# Transition Time and Transmitter Bandwidth

Mark Kimber (Semtech)

Figure 180-7—Reference receiver block diagram

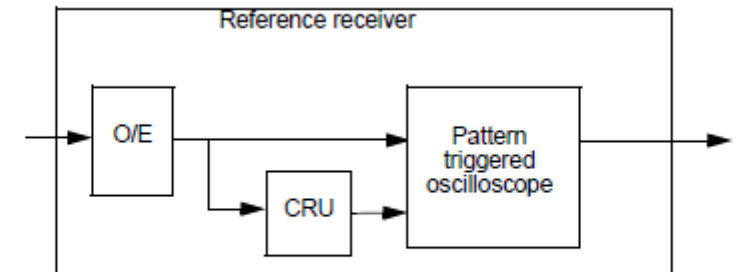
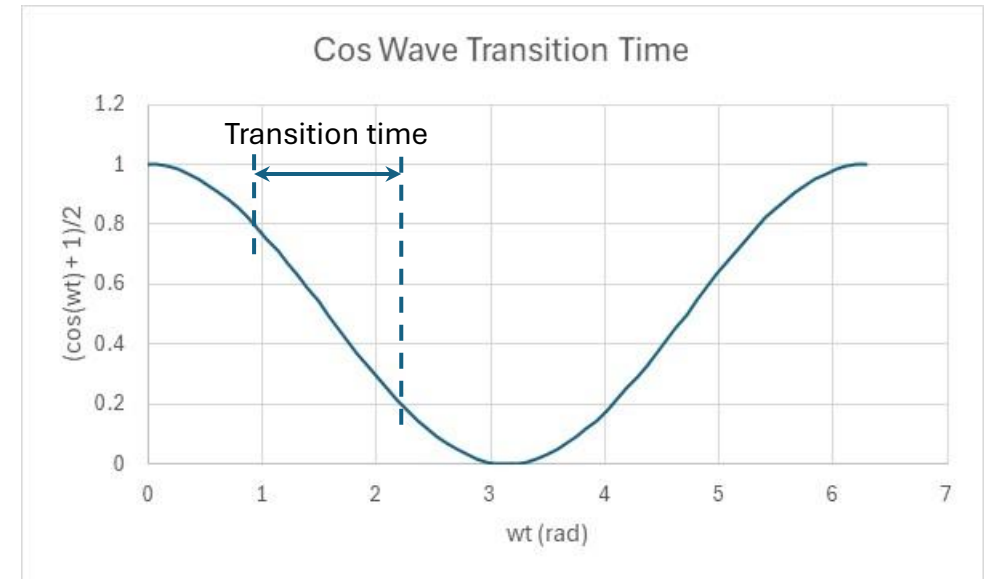
- Transition time is measured at the output of the reference receiver
  - Combination of O/E + oscilloscope is a 53.125 GHz Bessel Thomson response
  - Clock Recovery Unit (CRU) has a corner frequency of 4 MHz with a slope of 20 dB/decade
- Transition time is measured 20% to 80%
- 0% and 100% are defined as per OMAouter
- Patterns
  - Square wave (pattern 3)
  - SSPRQ (pattern 6)
